UNITED STATES PATENT AND TRADEMARK OFFICE  
CERTIFICATE OF CORRECTION

PATENT NO. : 7,359,643 B2  
APPLICATION NO. : 10/614112  
DATED : April 15, 2008  
INVENTOR(S) : Aronson et al.

FIG. 2B

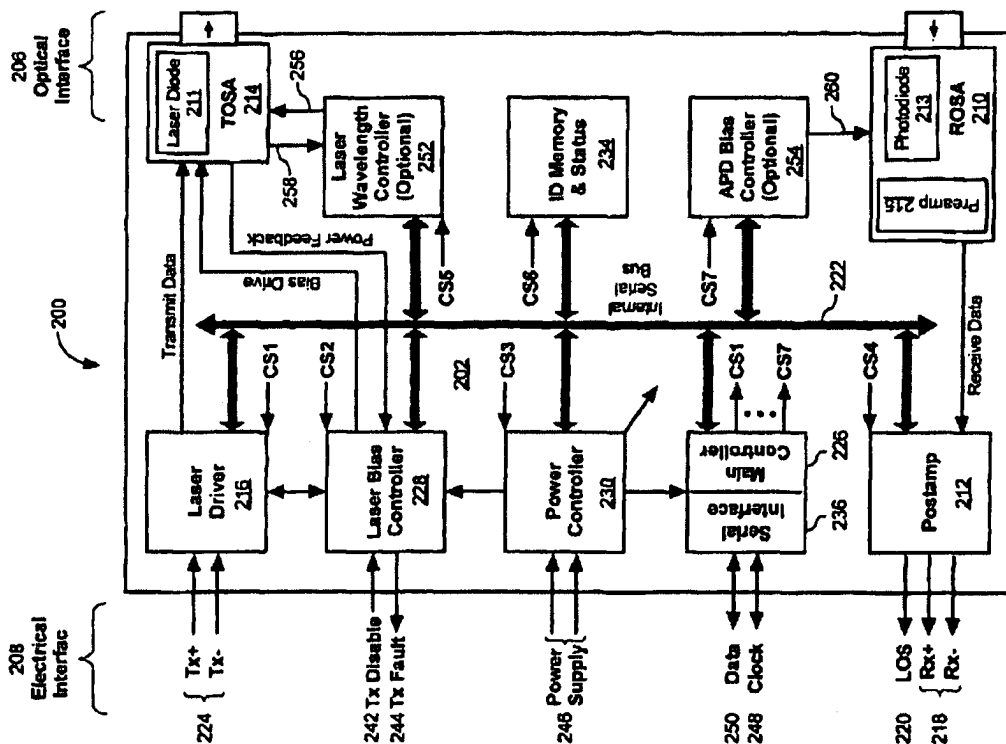
Sheet 3, replace Figure 2B with the figure depicted below, wherein preamp 215 has been added, laser temperature drive has been relabeled 256 and laser temperature or wavelength feedback has been relabeled 258
